Approved Section 4.55 (.....2.....) Modification Application

In respect to.....SSD 7484.....

SANDSTONE PRECINCT
23-39 BRIDGE STREET
SYDNEY, NSW, 2000

DEMOLITION ELEVATIONS LANDS BUILDING - SOUTH AND EDUCATION BUILDING - SOUTH

PROPOSED PLANS - LANDS BUILDING - LEVEL 04, EDUCATION BUILDING - LEVEL 03

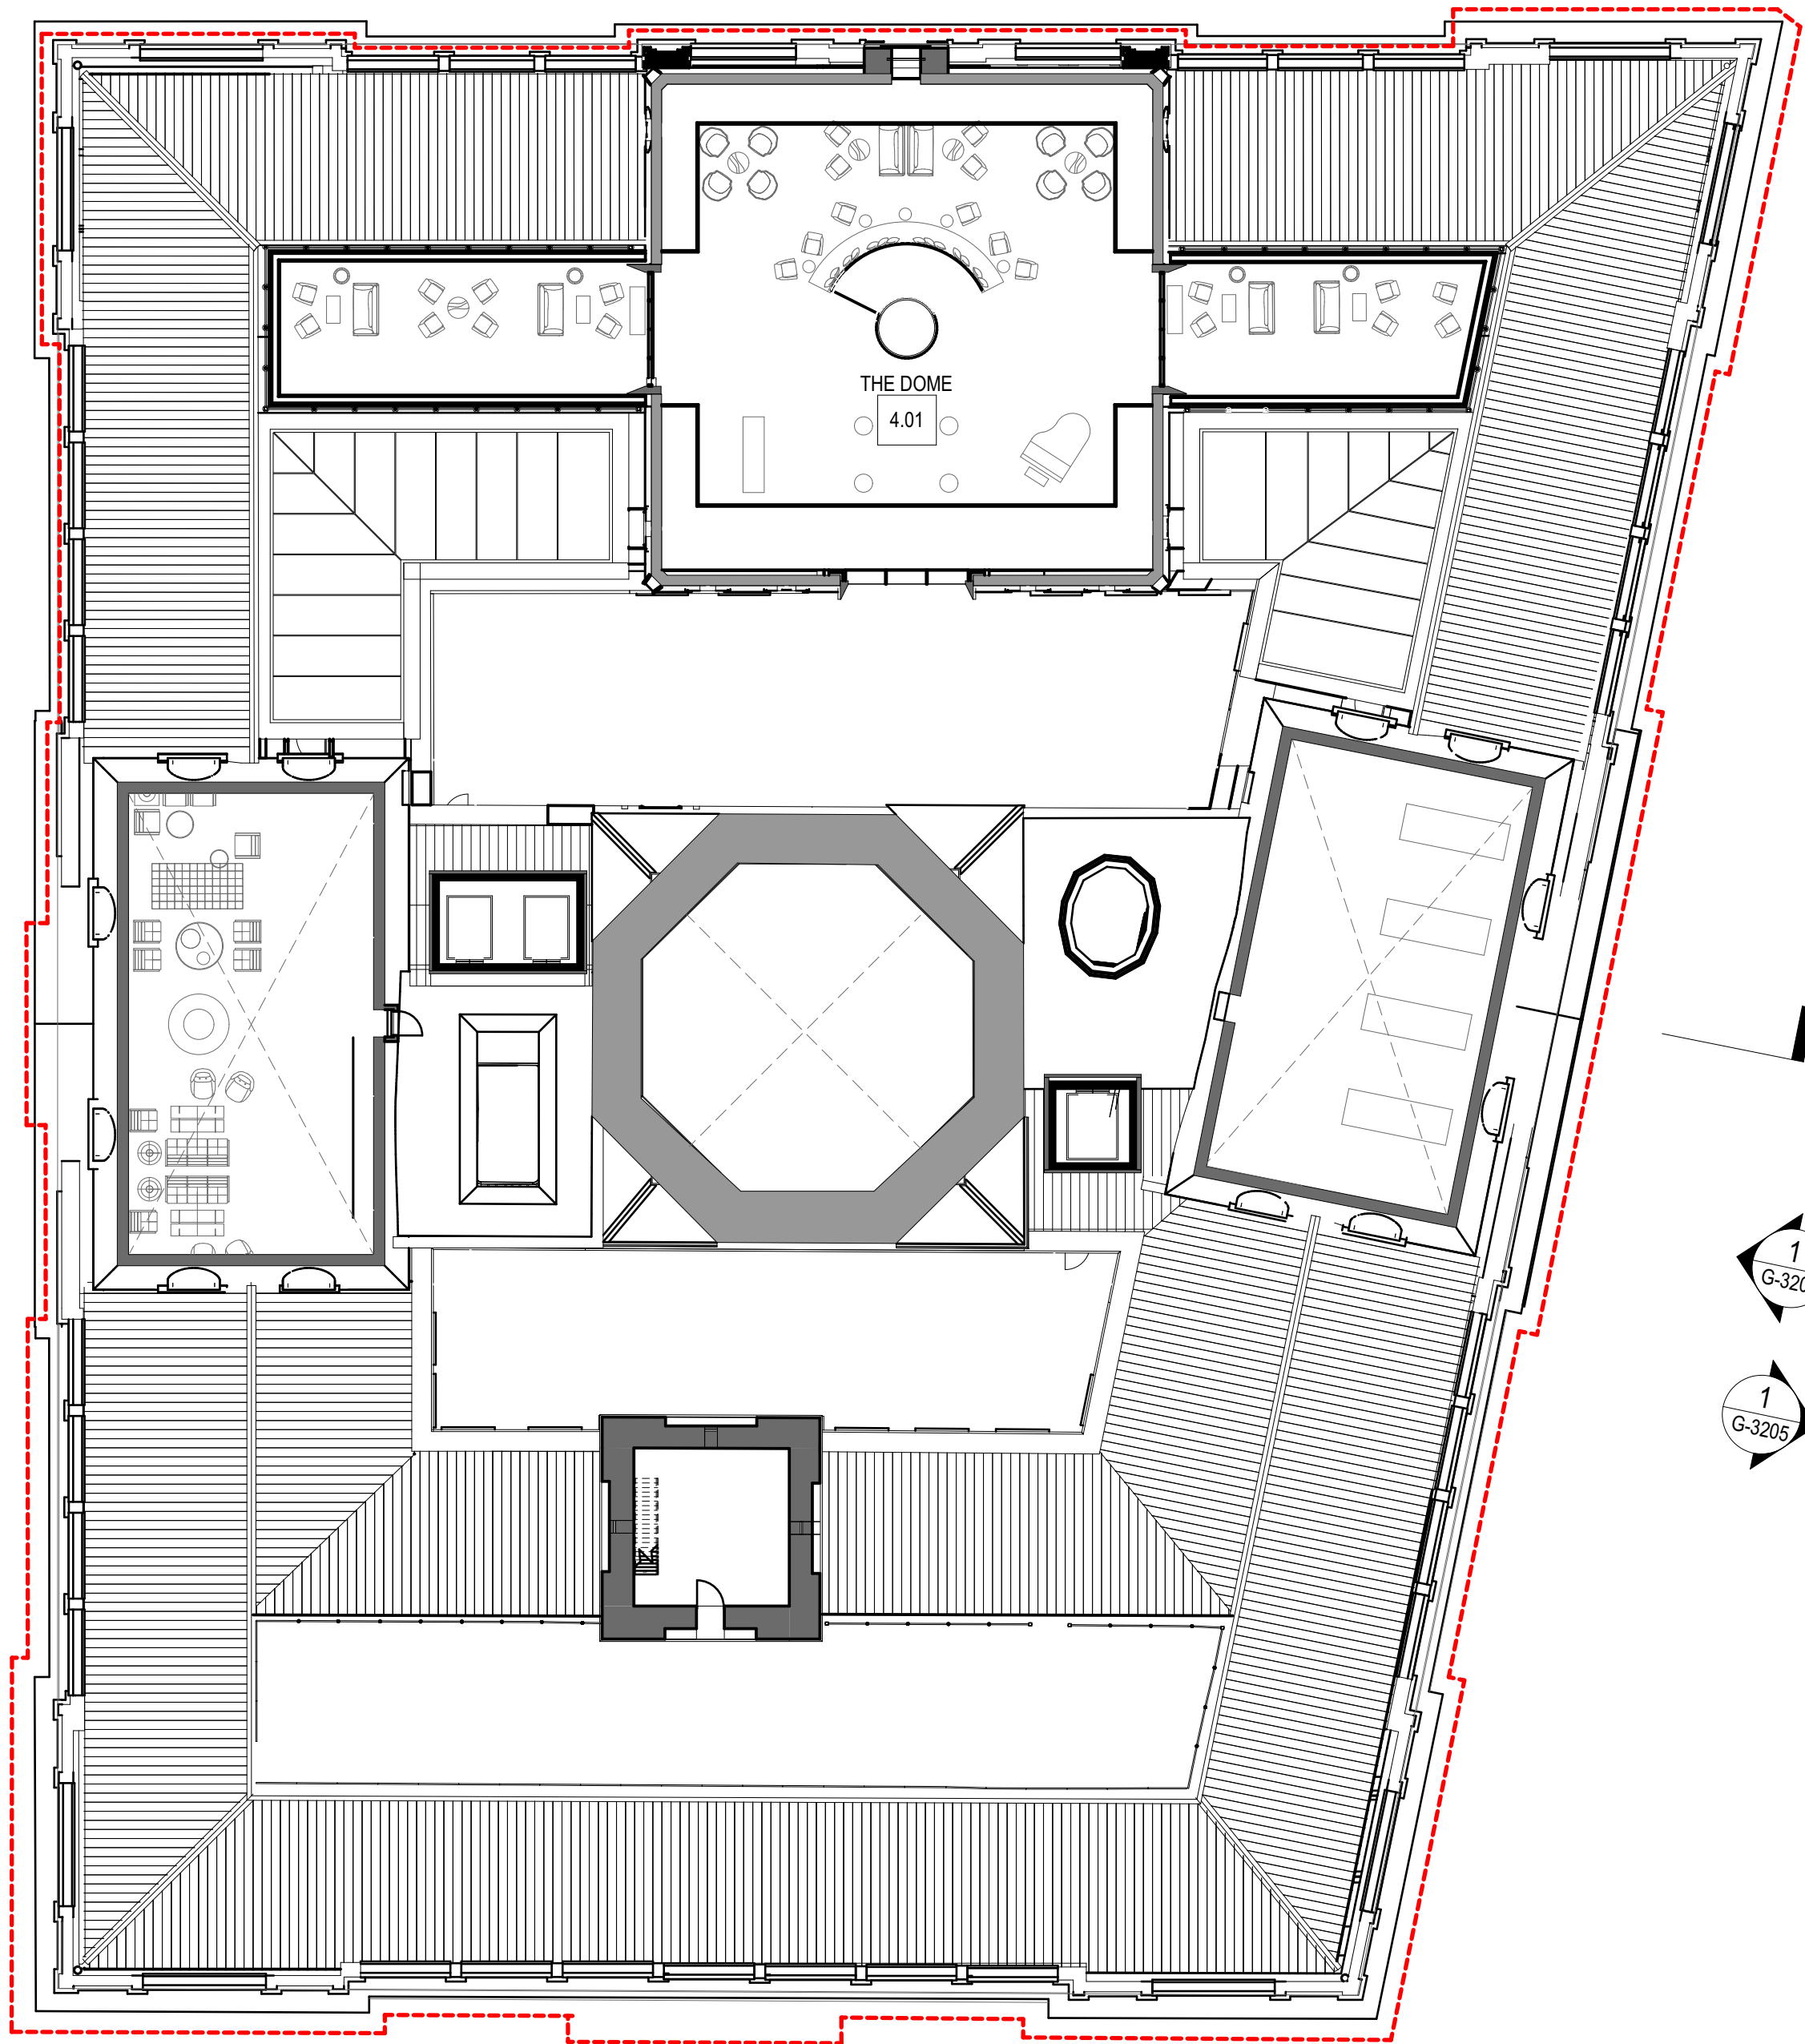
04 NEW COLUMNS ADDED TO ACCOMMODATE REVISED POOL STRUCTURE

PROPOSED PLANS - LANDS BUILDING - LEVEL 05, EDUCATION BUILDING - LEVEL 04

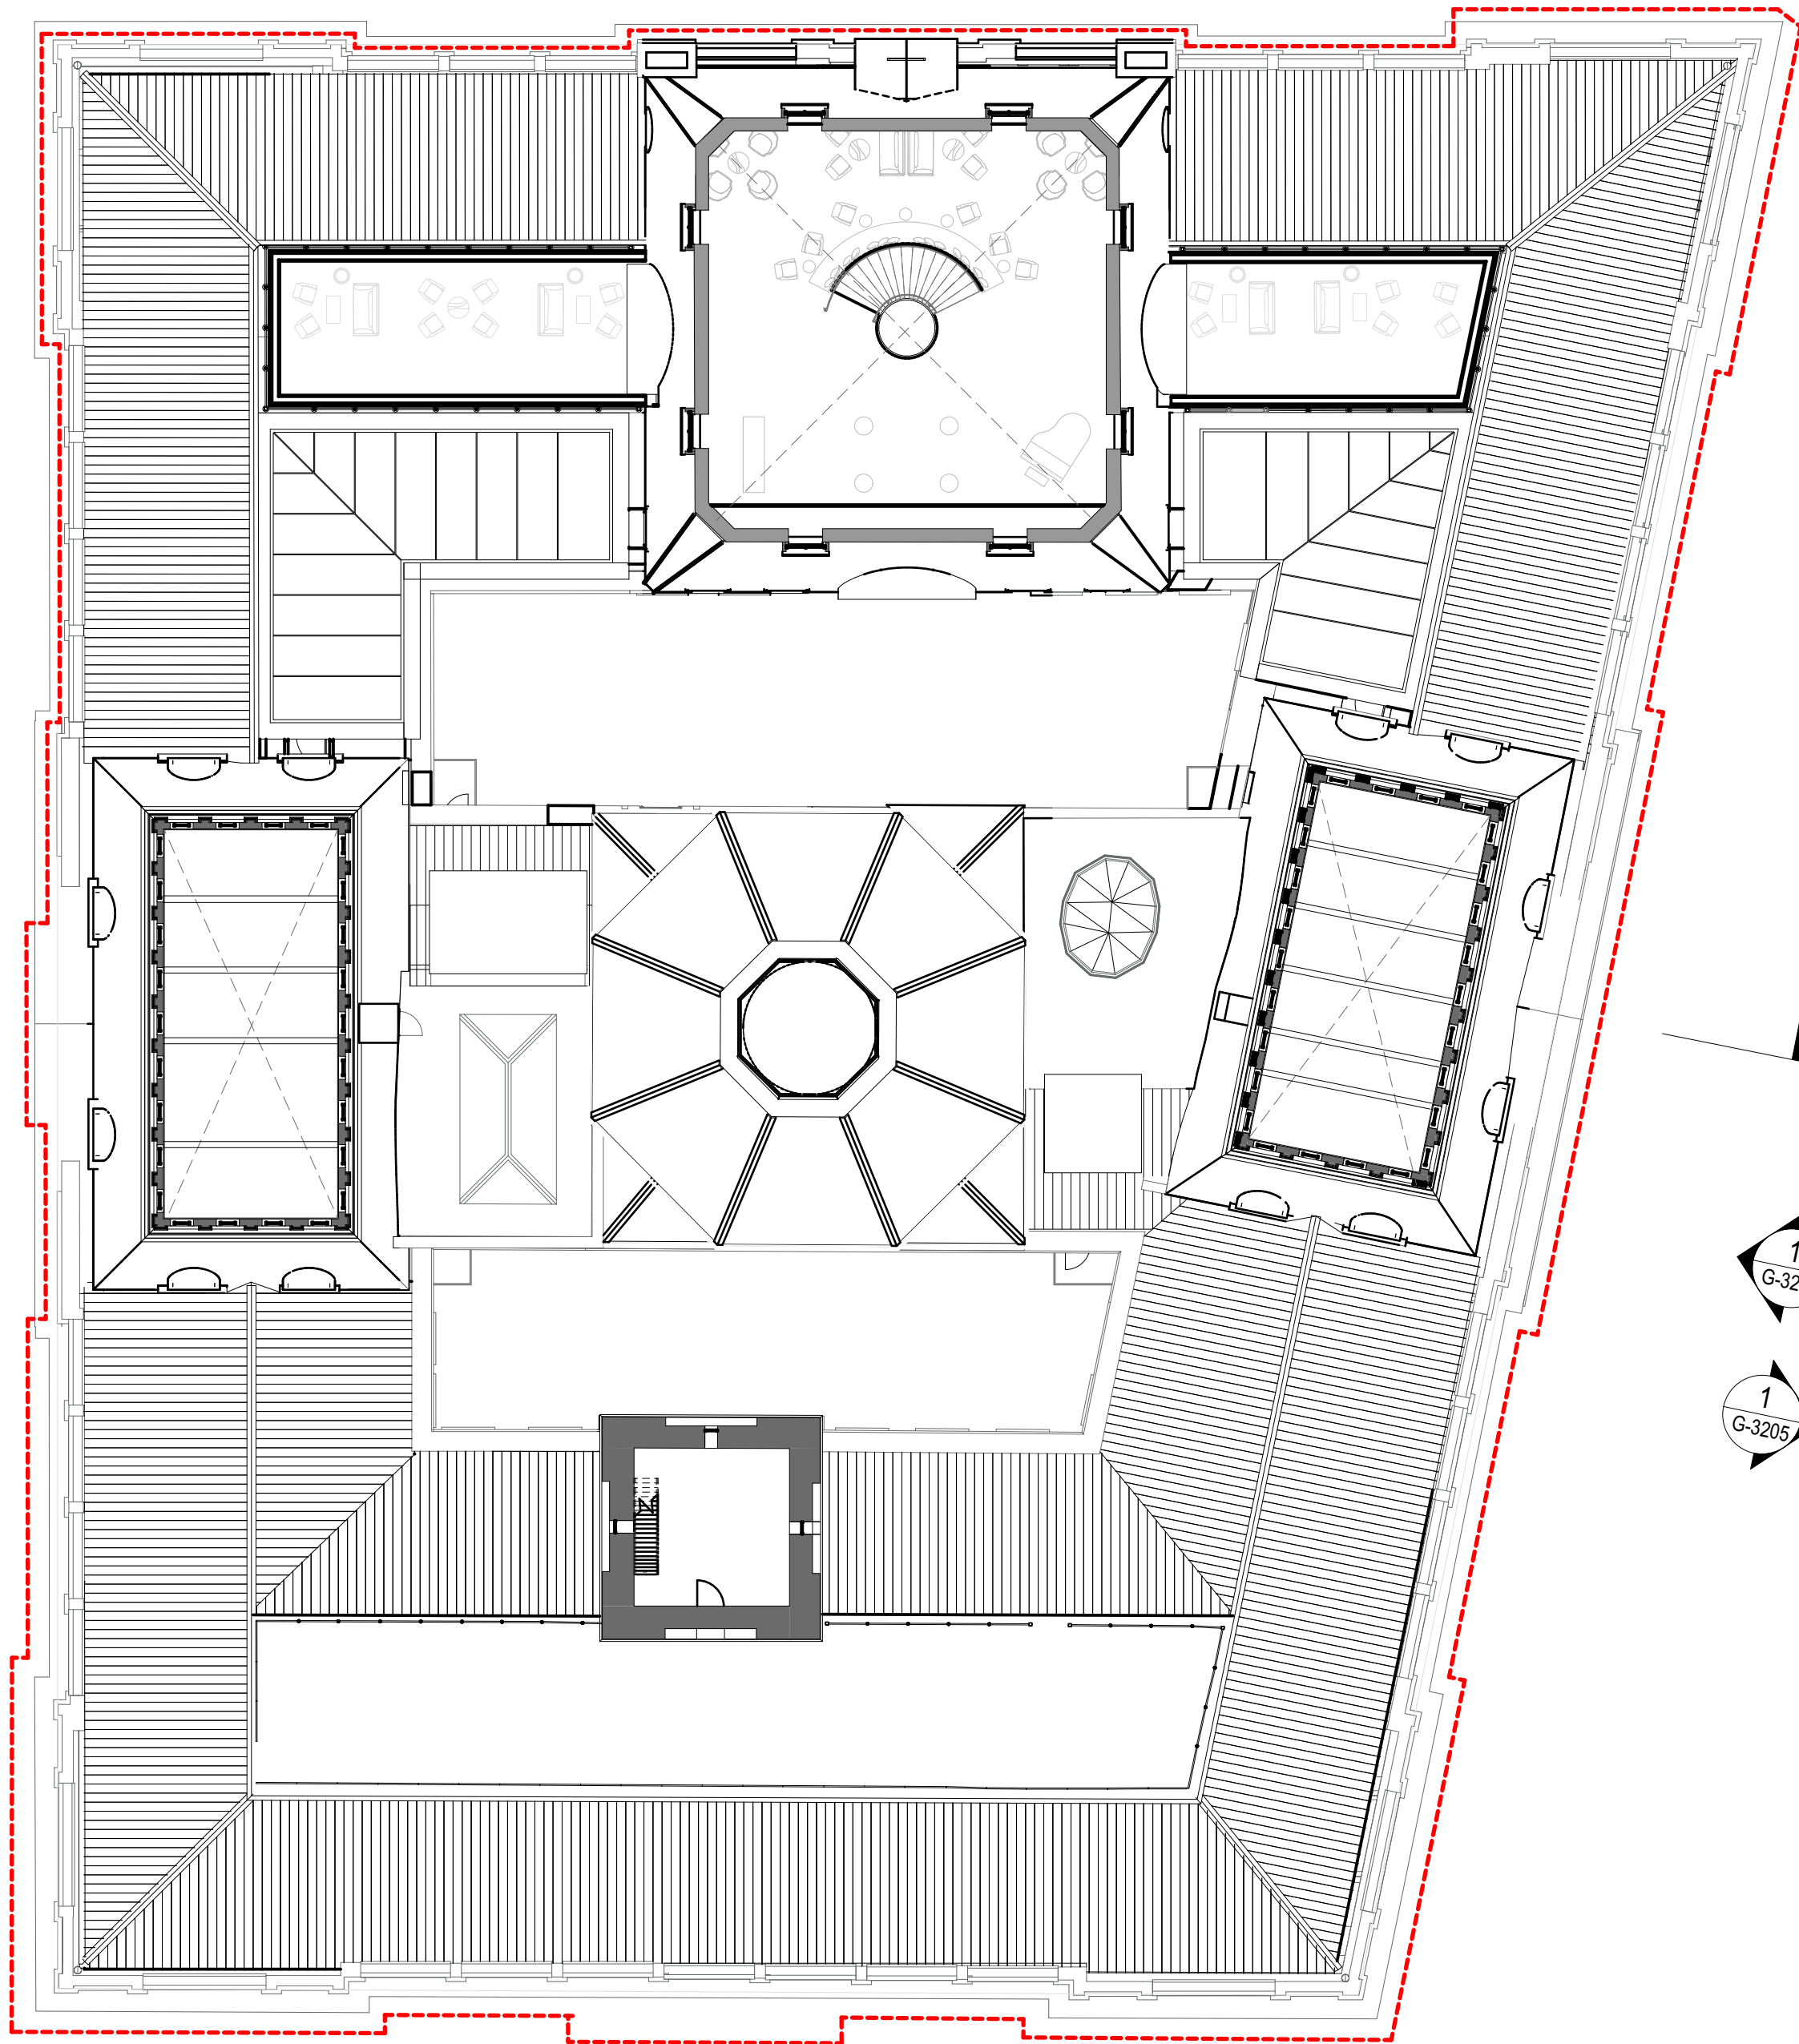
04 NEW COLUMNS ADDED TO ACCOMMODATE REVISED POOL STRUCTURE

TITLE
**PROPOSED PLANS - LANDS BUILDING -
LEVEL 06, EDUCATION BUILDING - LEVEL 05**

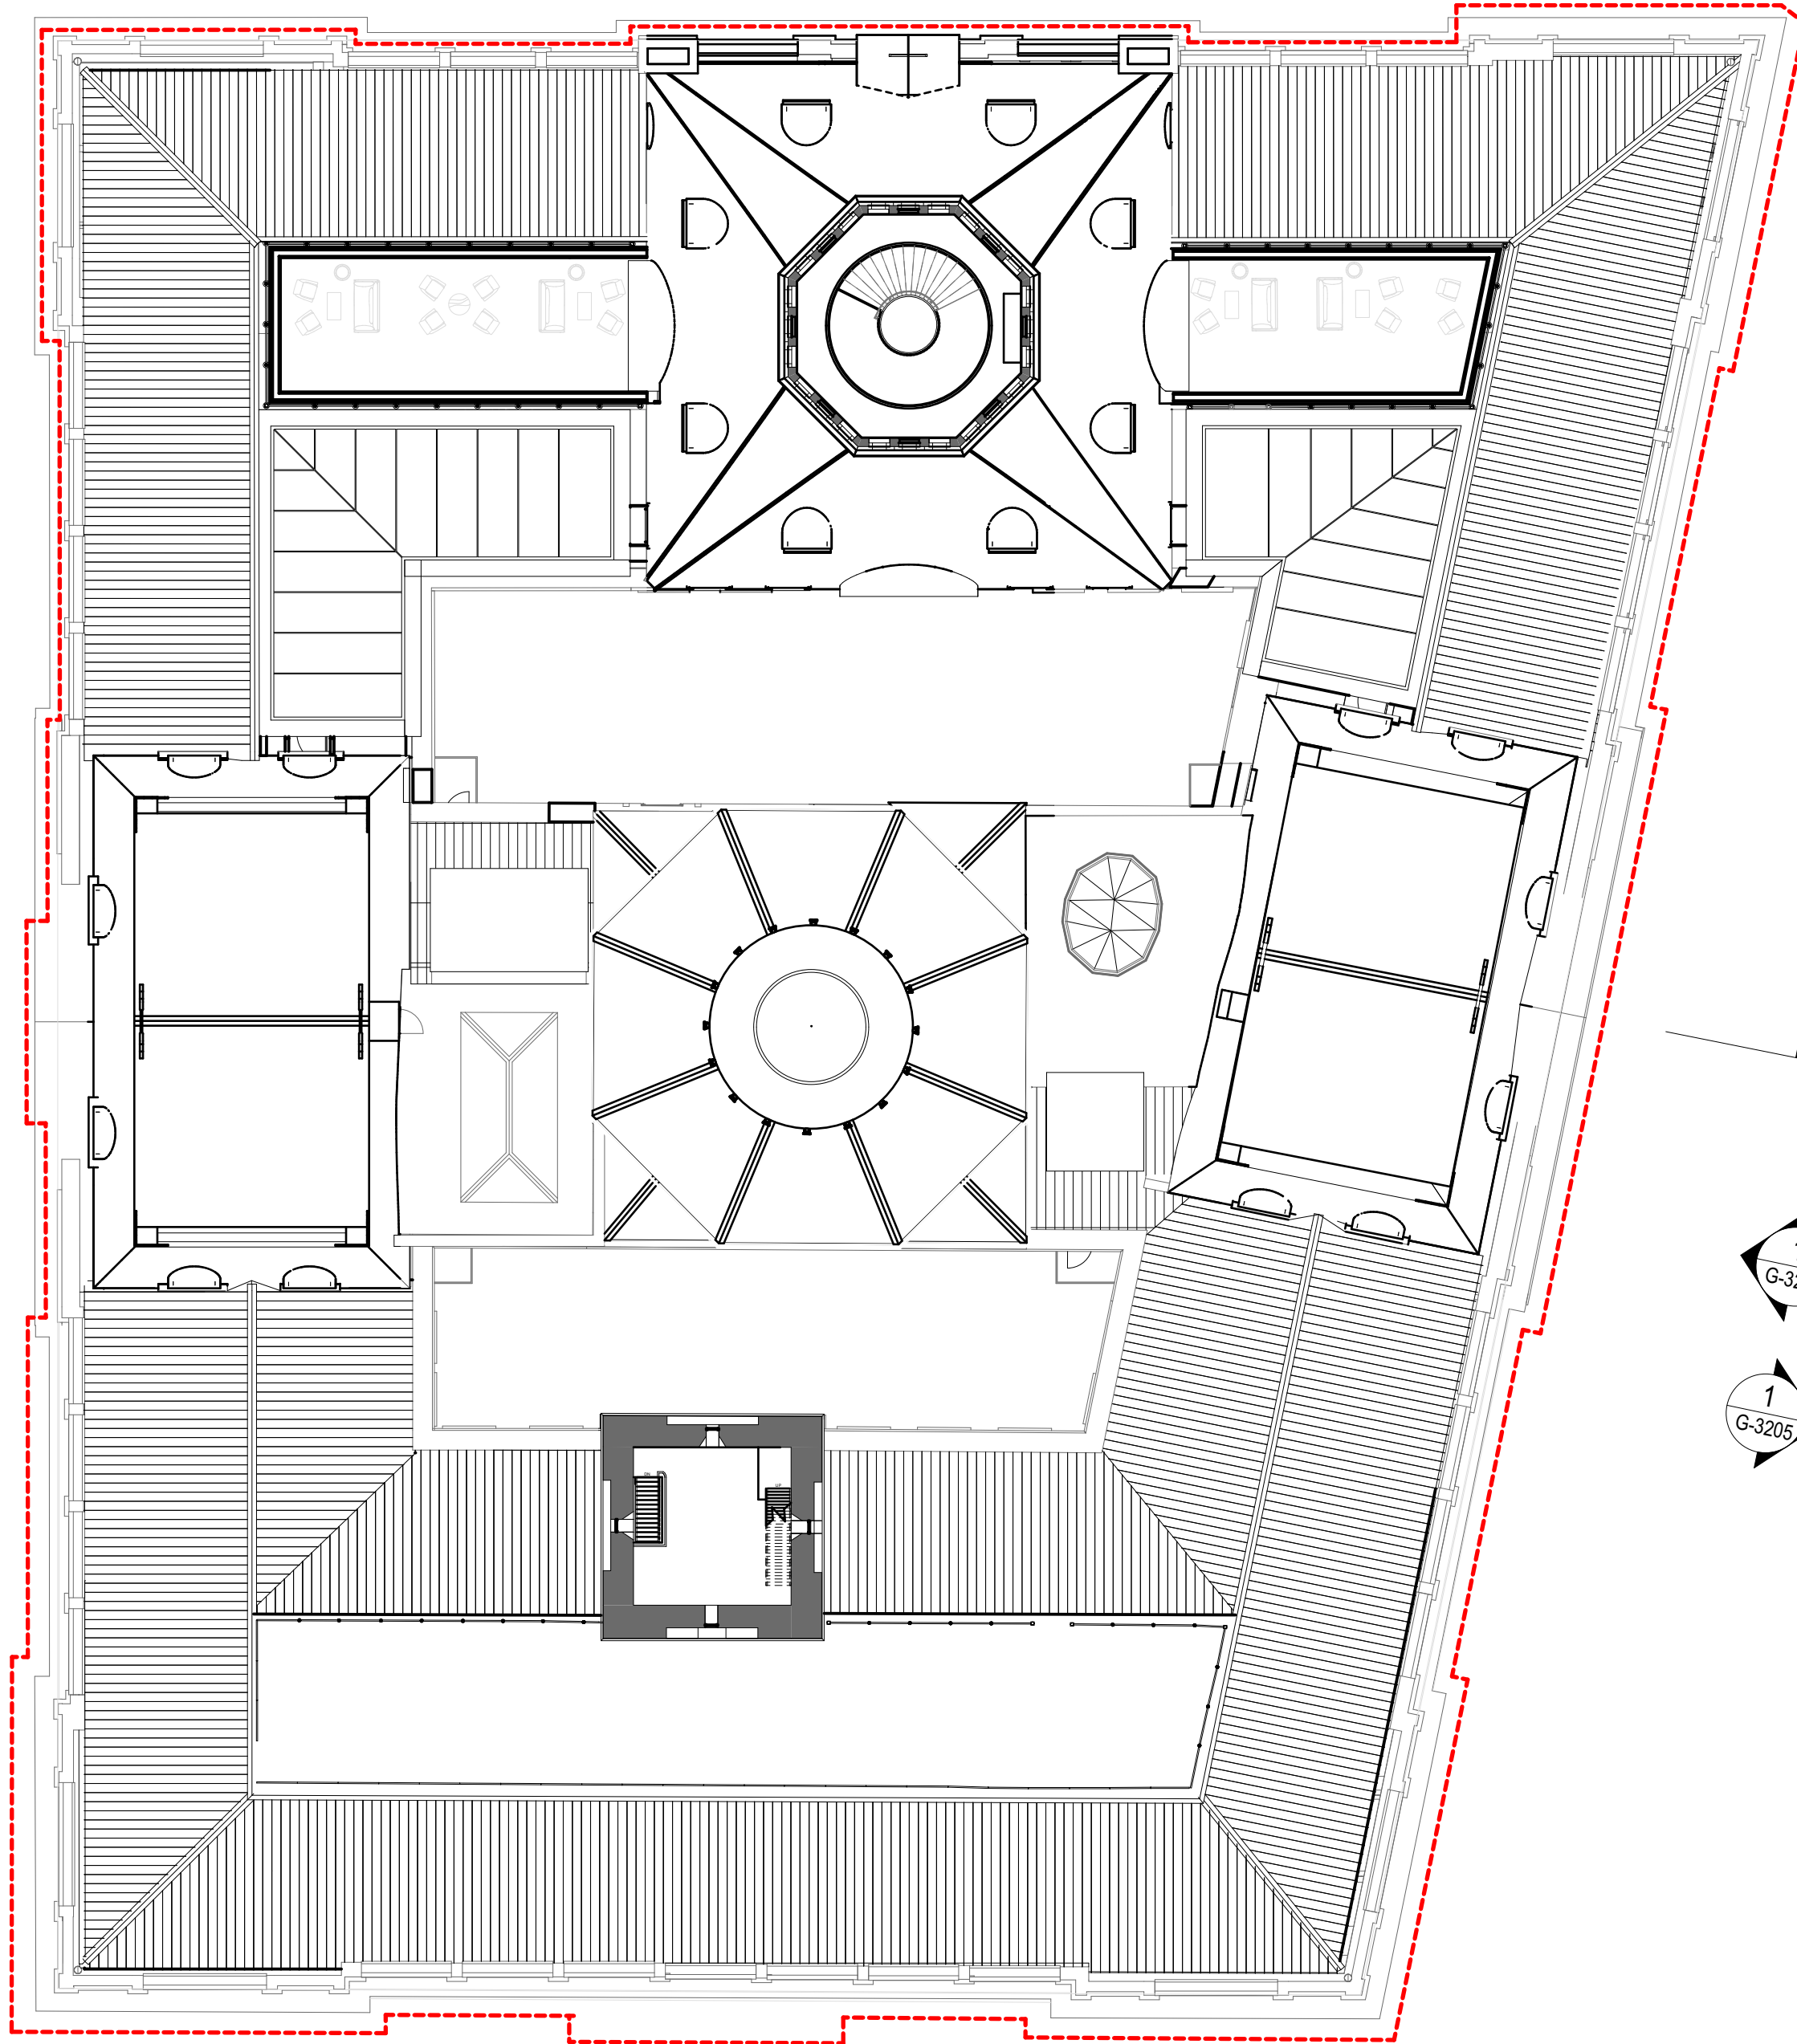
- CHANGES LEGEND:
- 01 STEPS ADDED BETWEEN GYM & POOL
 - 02 STEPS ADDED TO ADDRESS LEVEL CHANGE BETWEEN POOL & REST OF LEVEL
 - 03 LIFT ADDED TO ADDRESS LEVEL CHANGE
 - 04 DDA SAUNA ADDED
 - 05 AMALGAMATION AND RECONFIGURATION OF HOTEL ROOMS RESULTING IN A REDUCTION OF KEYS
 - 06 CHANGED FLUTED FACADE TO FLAT PANEL
 - 07 STAIR E08 RE-DESIGNED. TOP OF STAIR E01 UPDATED TO ACCOMMODATE LEVEL CHANGES
 - 08 EXISTING HERITAGE DOOR MODIFIED AND RELOCATED TO RECEPTION WALL. NEW DOOR TO STORE.
 - 09 GYM FLOOR LEVEL RAISED
 - 10 ACCESSIBLE CHANGE ROOM RELOCATED
